Proposed modifications to section 9.3 shown below

9.3 The stratified event scheduler

<NEW FIG 9.1>

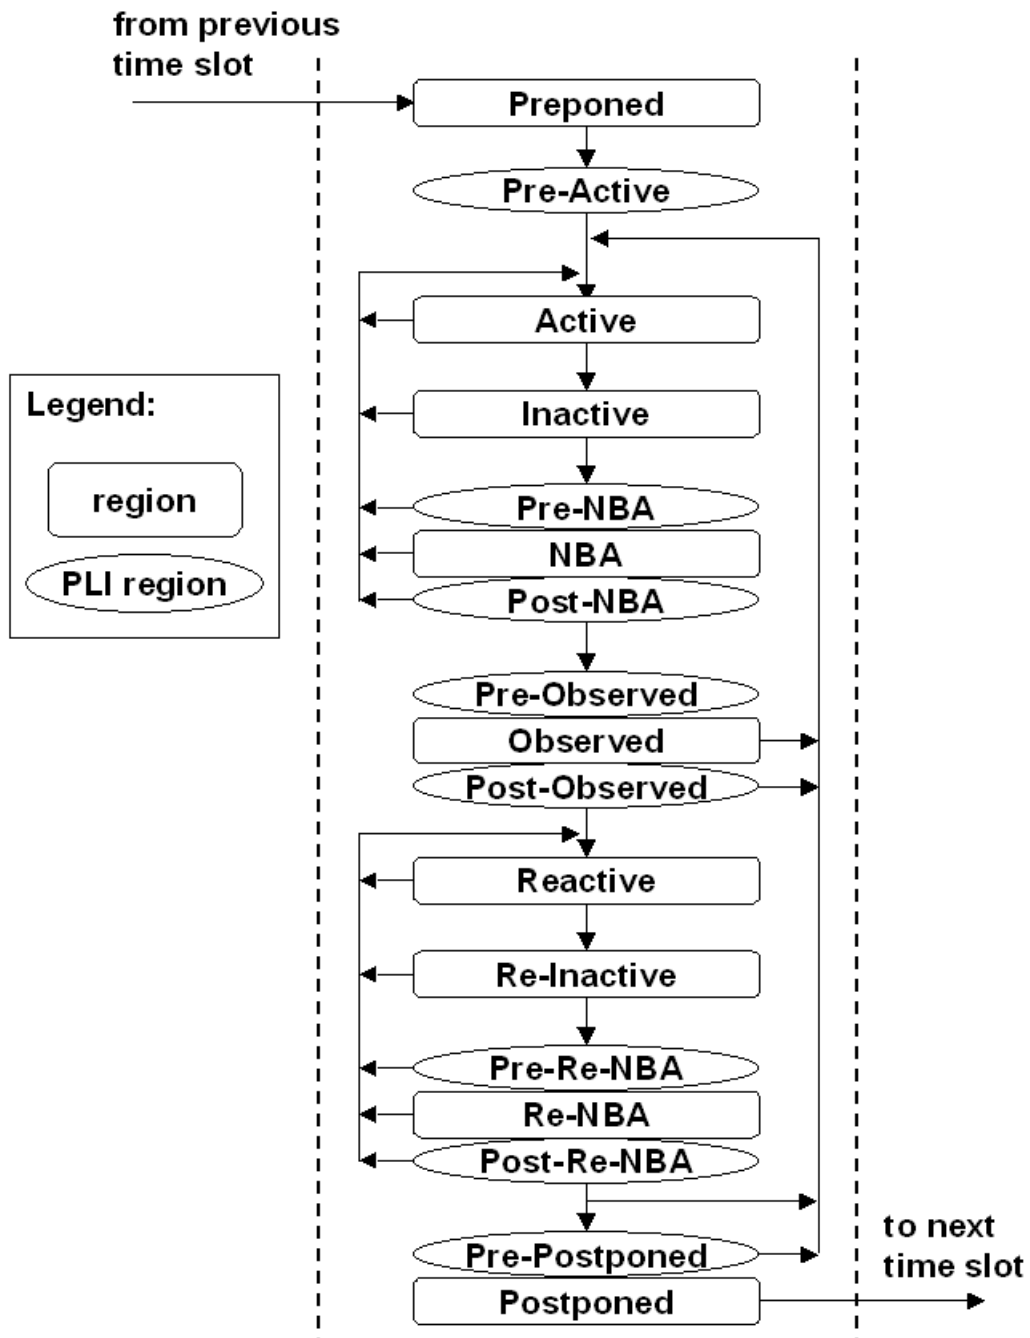
The simulation regions of a time slot are the Preponed, Active, Inactive, NBA, Observed, Reactive, Re-Inactive, Re-NBA and Postponed regions. The flow of execution of the event regions is specified in Figure 9-1.

In addition to the simulation regions, where PLI callbacks can be scheduled, there are additional PLI-specific regions. The PLI regions of a time slot are the Preponed, Pre-Active, Pre-NBA, Post-NBA, Pre-Observed, Post-Observed, Pre-Re-NBA, Post-Re-NBA and Pre-Postponed regions. The flow of execution of the PLI regions is specified in Figure 9-1.
